JAMES A. FITZPATRICK NUCLEAR POWER PLANT

AMENDMENT TO FACILITY OPERATING LICENSE

Amendment No. 78  
License No. DPR-59

SAFETY EVALUATION BY THE OFFICE OF NUCLEAR REACTOR REGULATION

FIGURE 6.1-1

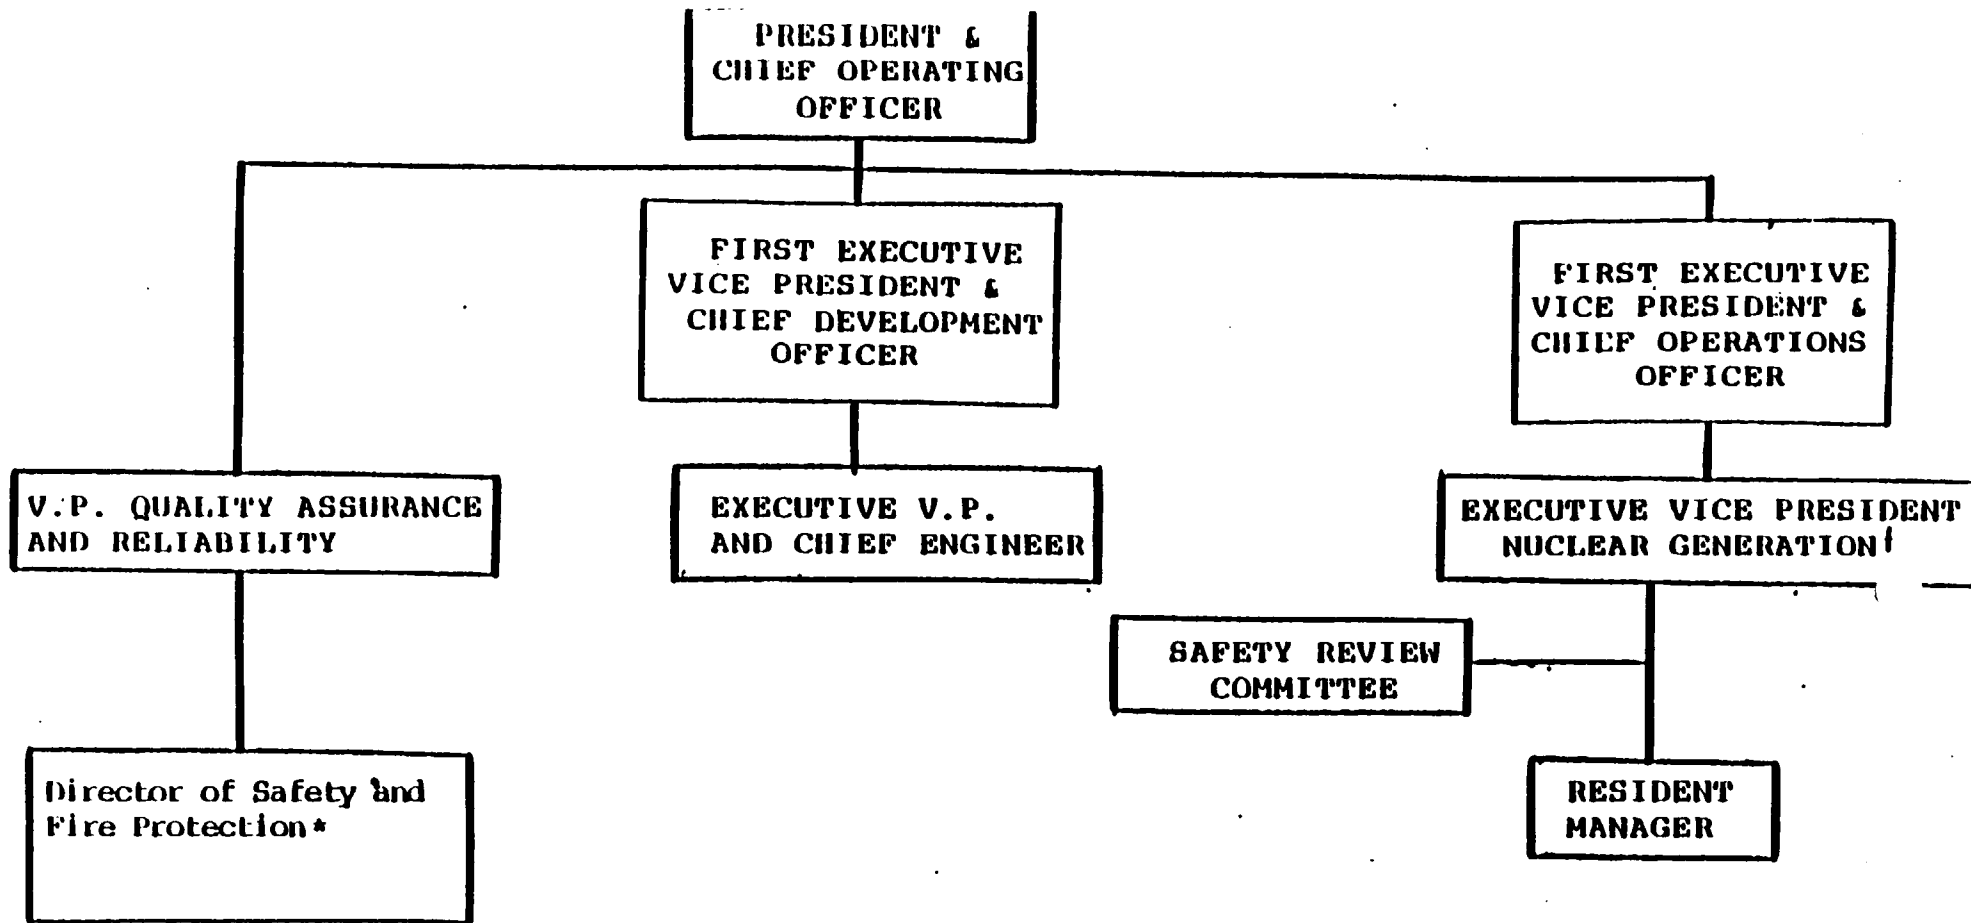
1. The off-site management organization has been revised to add the position of First Executive Vice President and Chief Development Officer and the position of First Executive Vice President and Chief Operations Officer. The title of Executive Vice President Procedures and Performance has been changed to Vice President Quality Assurance and Reliability; and he assumes the duties held previously and, in addition, now performs audits and appraisals of the security program. The title of Senior Vice President Nuclear Generation has been changed to Executive Vice President Nuclear Generation without change of function; and the title of Director of Safety and Fire Protection Procedures and Performance has been changed to Director of Safety and Fire Protection.

Title changes have been made throughout Section 6 of Appendix A and in Figure 5.2-2 of Appendix B to reflect the above reorganization and title changes. The reorganized off-site management organization is shown in revised Figure 6.1-1.

FIGURE 6.2-1

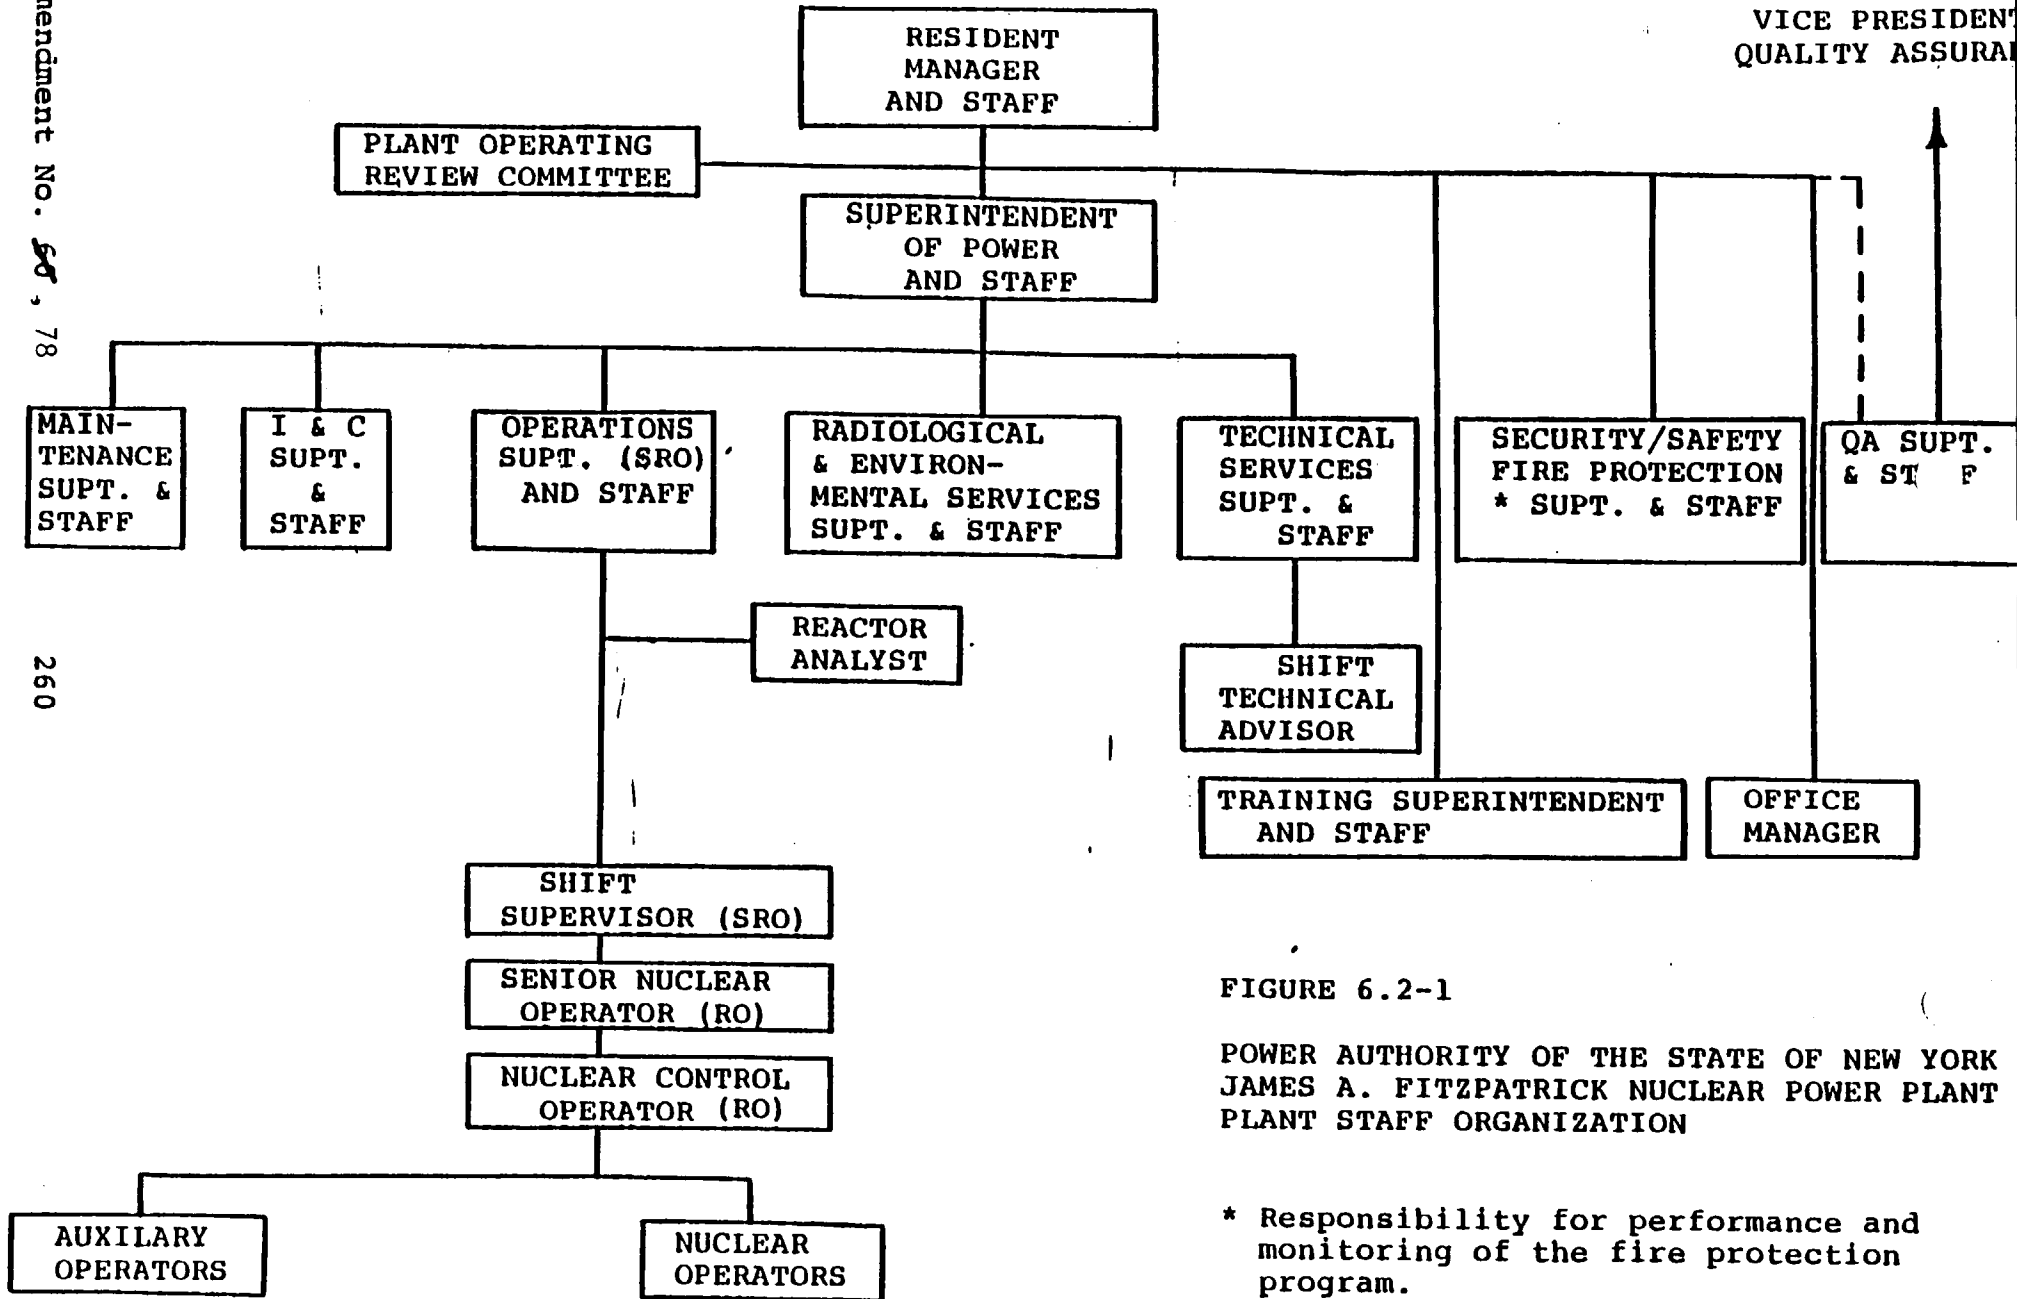
2. The plant staff organization chart has had a footnote added that assigns responsibility for performance and monitoring of the fire protection program. Additionally, the title of Training Coordinator has been changed to reflect the current organization structure. This is shown in Figure 6.2-1.
3. In Section 6.5.2.8, the audit frequencies for emergency preparedness and safeguards contingency plans (Items e and f) have been revised to agree with 10 CFR 50.54(t) and 73.40(d) respectively.
4. The title of the Plant Radiation Protection and Radiochemistry Supervisor has been changed to Radiological and Environmental Services Superintendent in Section 6.11.
